American Hakko Products, Inc.

PRODUCT BULLETIN

Bulletin No: PB374

NEW G2 Series Blades for the HAKKO FT-801 Thermal Wire Stripper

G2-A1601, G2-A1602, G2-A1603

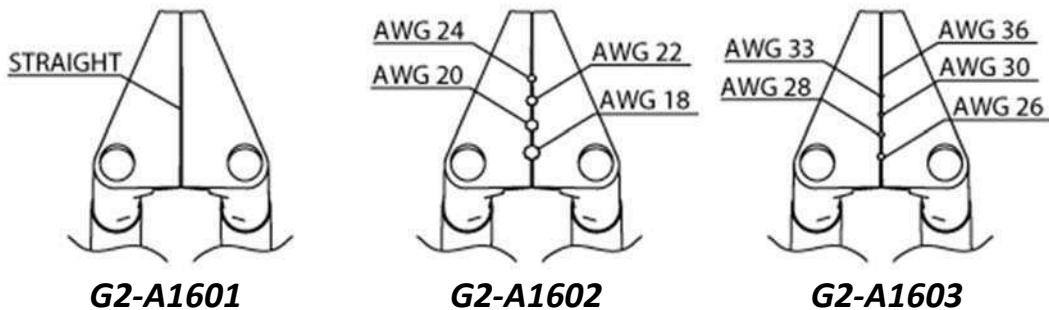
These new G2 Blade Sets for the HAKKO FT-801 Thermal Wire Stripper include a wishbone support between them that is attached to the collar. This support mitigates rotational play in the blades to improve notch alignment at the end of the blades when tighter tolerances are required.
